Westfield Energy Conservation Park

Highways Technical Note

Response to Highways Comments from Hertfordshire County Council (HCC)

Planning Application Reference: 25/01947/FP. HCC Reference: NH/26213/2025

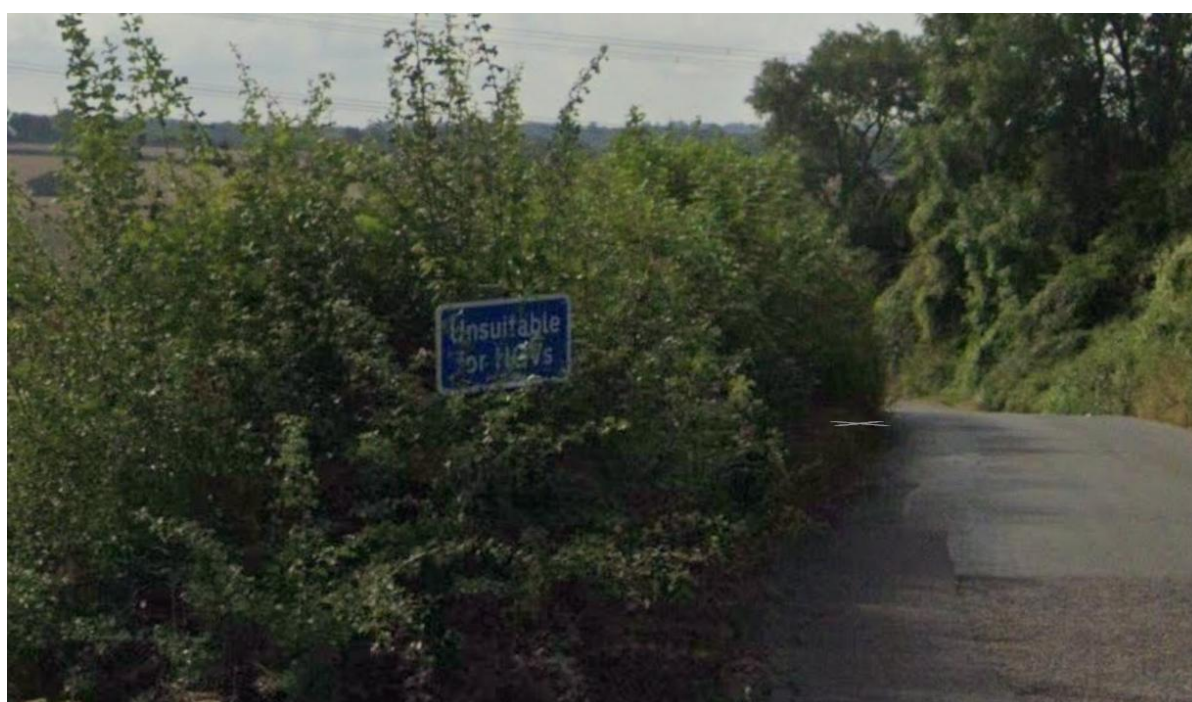
The revised drawing (Ref: AMA-23064-SK-001-3.3 P07) indicates a primary site access arrangement that remains unsupported by the Stage 1 Road Safety Audit (RSA). The Highway Authority considers the proposed access location and design to be substandard when assessed against the scale of the proposed development and its forecast traffic generation. In this context, the Highway Authority would be amenable to considering the relocation of the existing access further south onto Cromer Heath, where a safe and secure primary site access could be more appropriately accommodated.

As requested, the potential relocation of the primary (eastern) site access further to the south has been carefully considered. However, facilitating an access at this location would necessitate the removal of a substantial amount of vegetation, including mature trees and hedgerows, along the western side of Cromer Heath. This level of environmental impact is considered unacceptable with Hedgerows being a UK Biodiversity Action Plan priority habitat and particularly given that the access in question is required only on a temporary basis for construction purposes and for a minimal number of vehicles for maintenance during operation of the site. The removal of any hedgerow would also impact on nesting birds where active nests and their eggs are strictly protected under the Wildlife and Countryside Act and also any potential dormouse on site. Furthermore, there are two PRF-M trees on Cromer Heath which have features suitable for bat maternity roost.

On balance, the relocation of this access would not provide a material benefit when weighed against the permanent loss of vegetation and the impacts on Biodiversity Net Gain (BNG). Furthermore, a suitable existing access point is already available and is considered appropriate for construction and occasional maintenance access. These constraints and their implications were clearly set out and discussed with

both the planning and highways officers at the meeting in which the planning officer agreed there would be significant ecological implications in moving the access further south.

Furthermore, vehicle weight restriction signs shown below are in place on Cromer Heath just south of the existing access which prohibit heavy goods vehicles from travelling further south of the existing access on Cromer Heath.

No construction vehicles are currently proposed to be routed south of the site on Cromer Heath due to the narrow width of the carriageway south of the existing access which is unsuitable for HGVs. It is considered that Cromer Heath is too narrow to allow a HGV to turn into and out of the site further south of the existing access.
